Merger Project Team Meeting Agreement

Project Name/Description: Greensboro Eastern Urban Loop from US 70 Relocation to
SR 2303 (Lawndale Drive) in Guilford County

TIP Project No.: U-2525 B and C

MEMO TO FILE / NOTES FROM U2525B & C MERGER 2A & 4A MEETING HELD ON 04/11/06

SITE 10

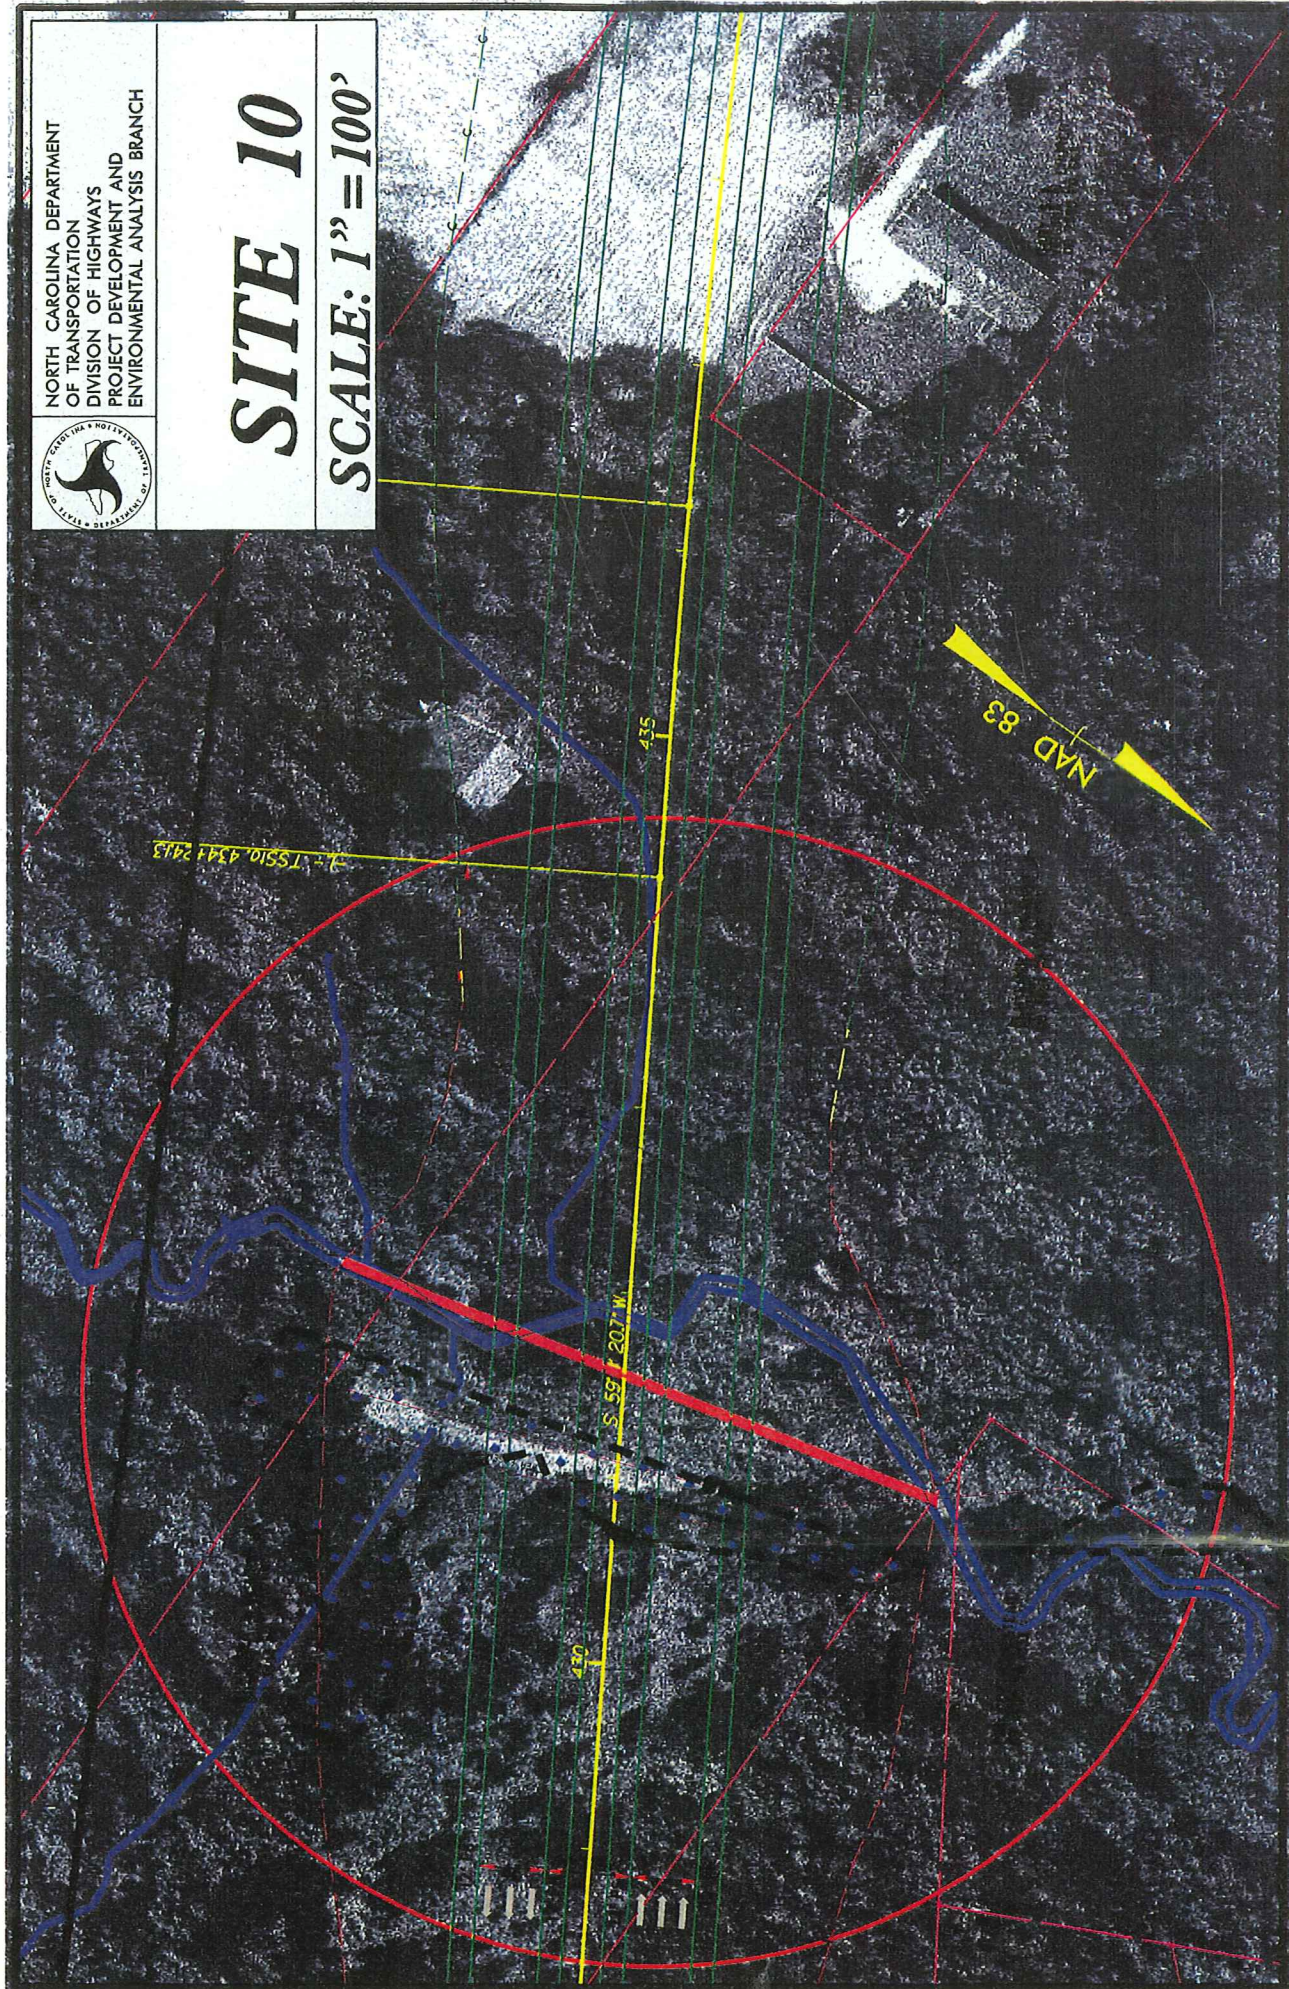
- Site 9: the agency would rather visit the site and make recommendation whether on-site mitigation is feasible or not
- Site 10: agency is OK with culvert but expressed concern with all the tributaries tying in, will visit the site

SITE 11

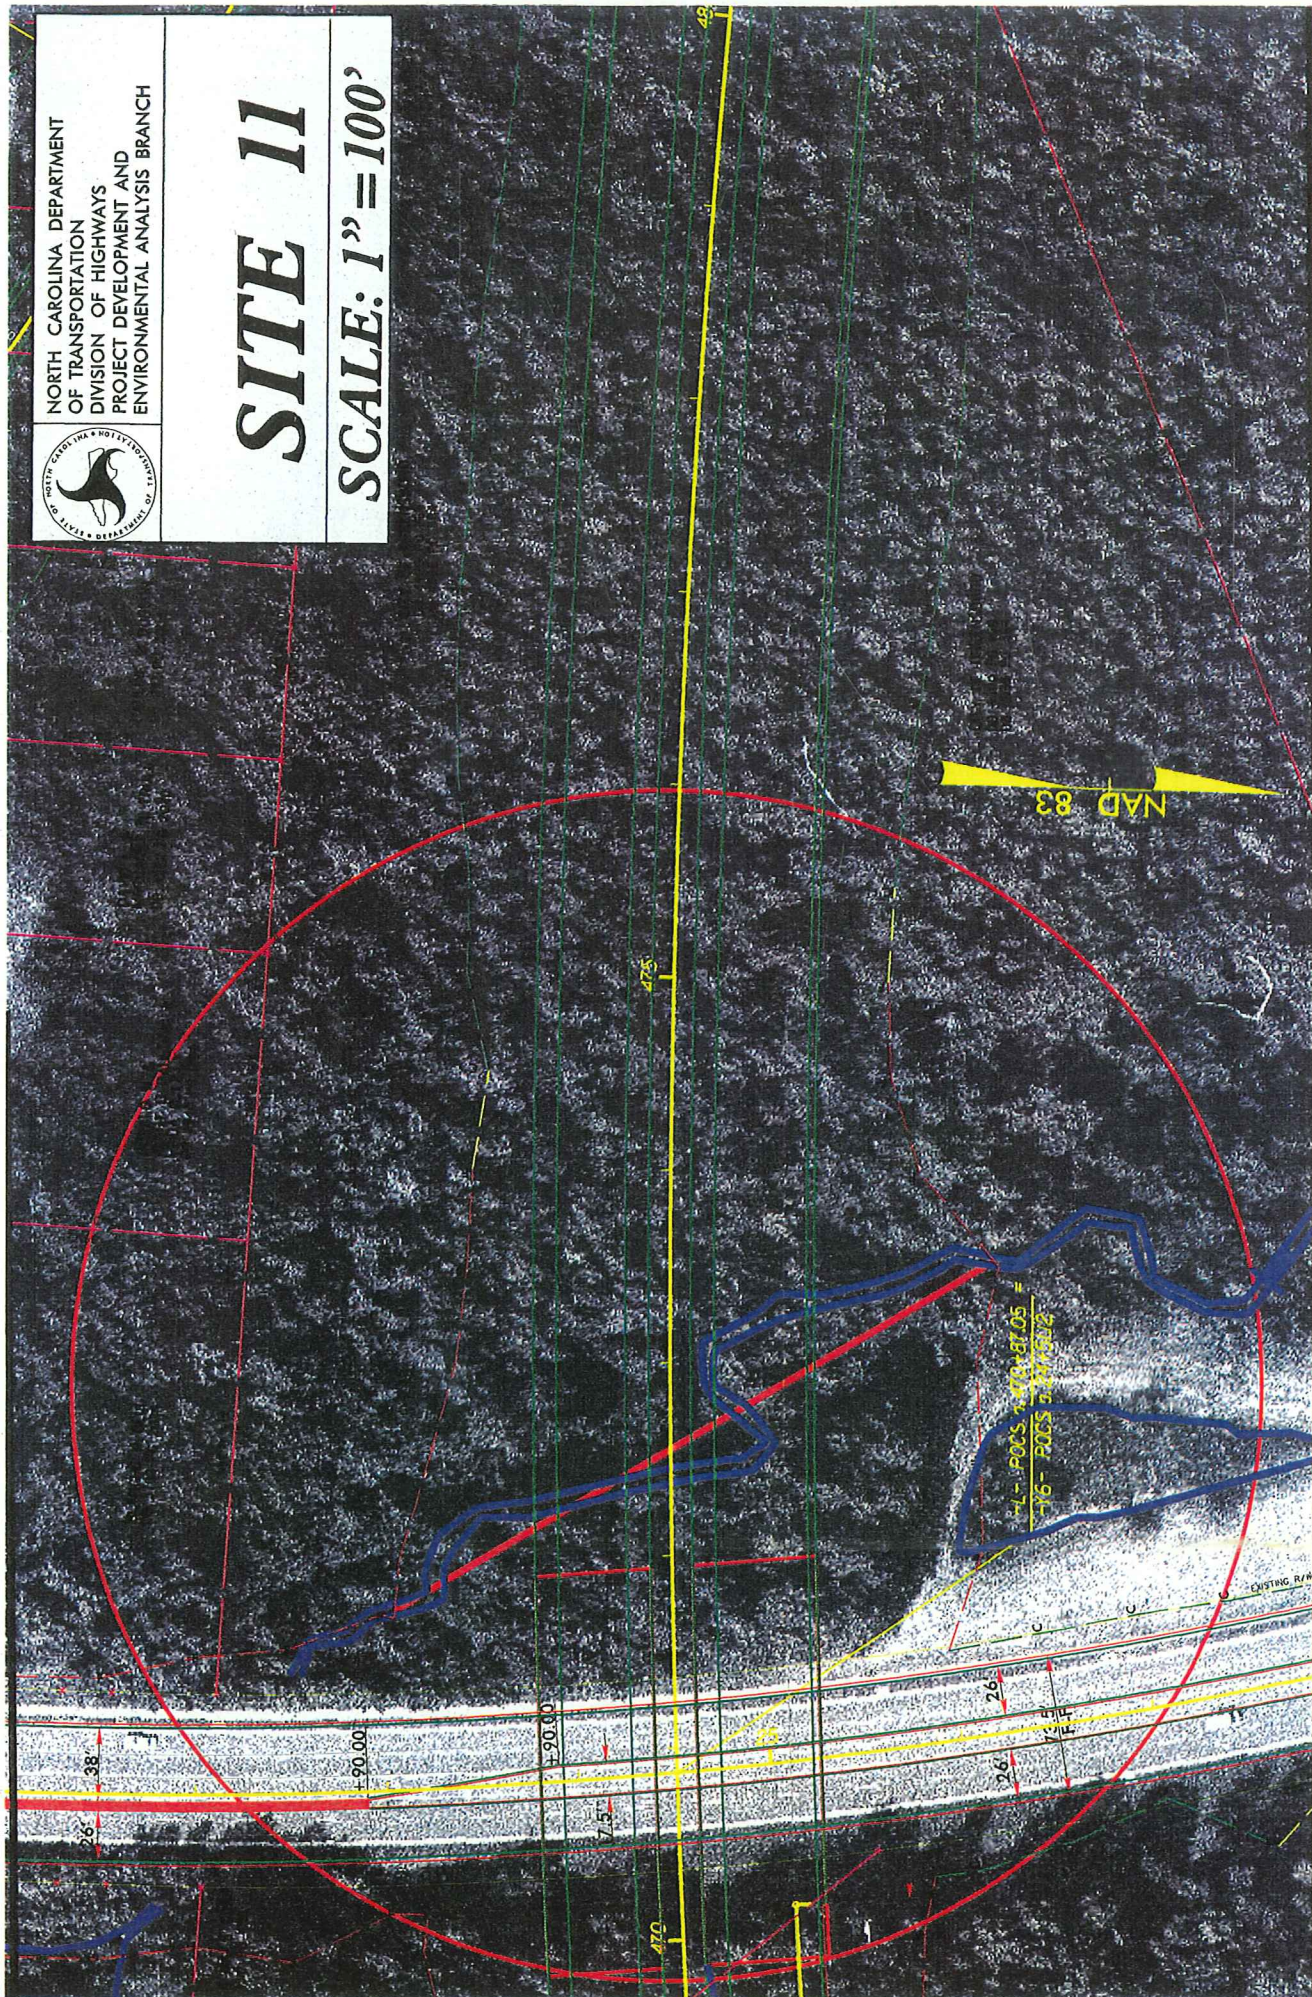
- Site 11: the ramp in NW quadrant was eliminated and a loop was added in NE quadrant to minimize the impacts; it was mentioned about partial stream relocation and extension of the bridge of about 100' to 150' to cover the stream, however, more information will be available for the 4B meeting

SITE 12

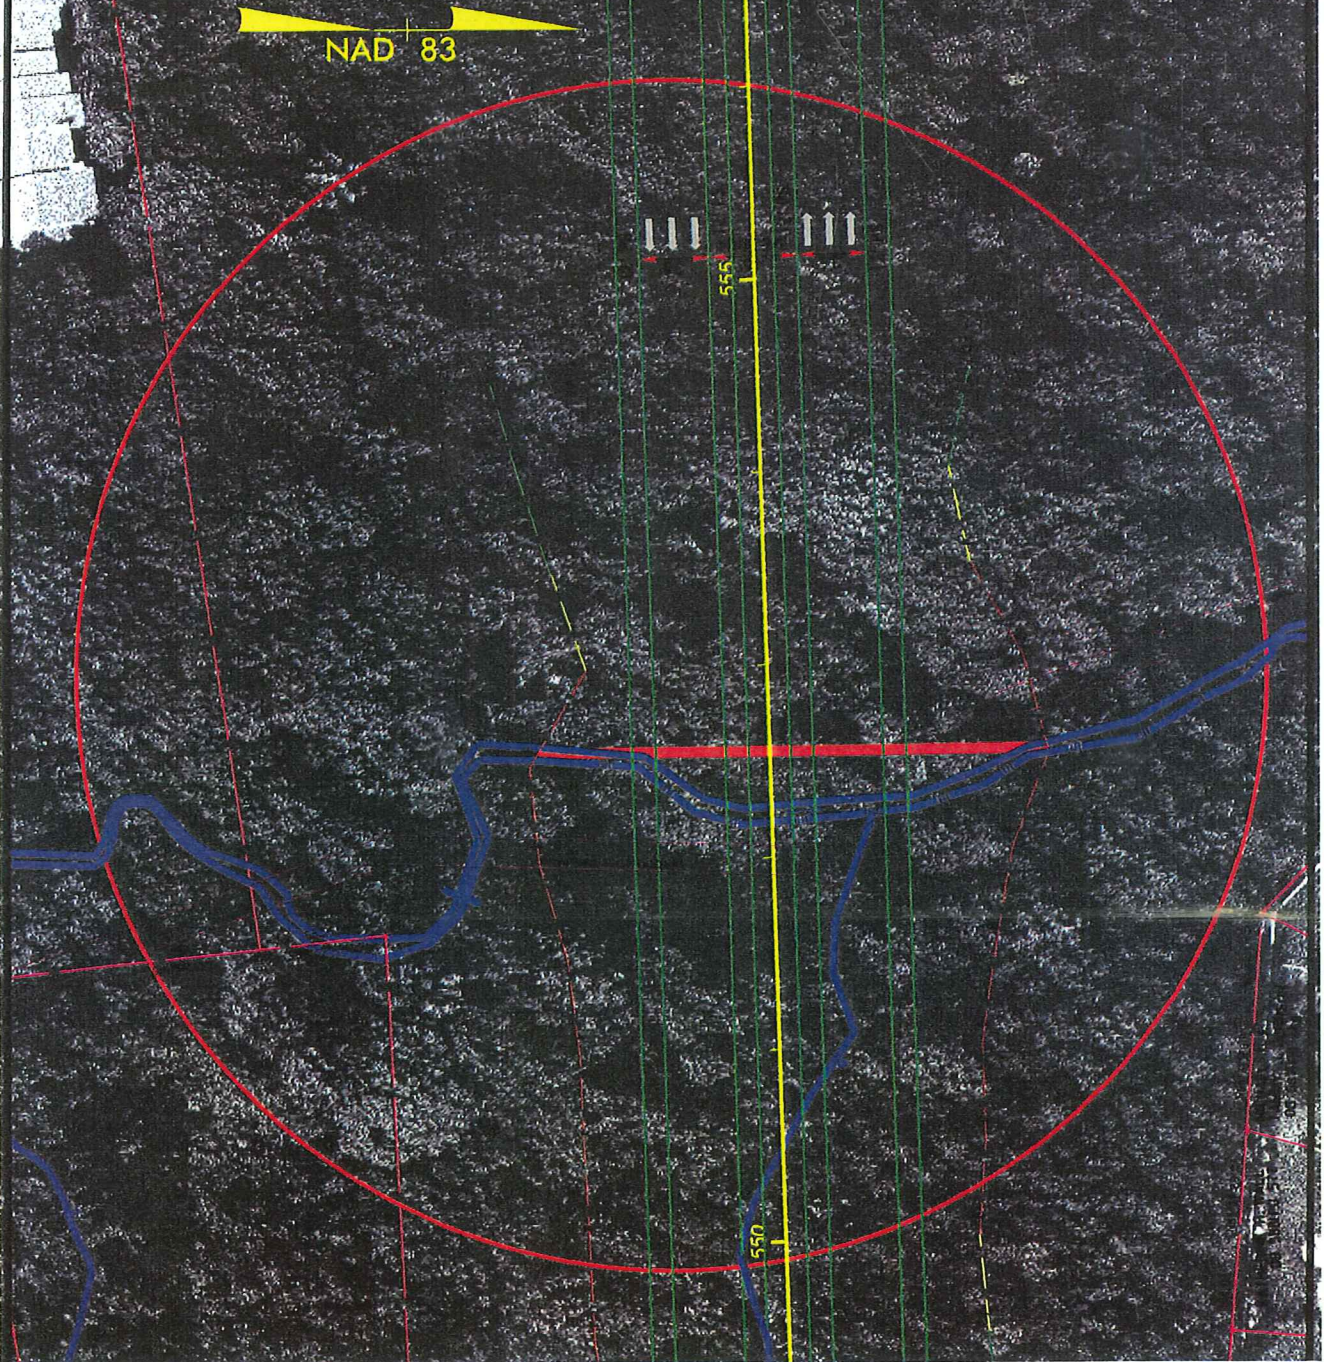
- Site 12: no alignment shift is possible since the slope stakes are on the edge of every development
- Site 13: previously the site contained a pipe, since the project was upgraded to urban it requires at least a culvert in it's place, however, the bridge will be extended additional 40' to encompass the stream and eliminate a potential box culvert
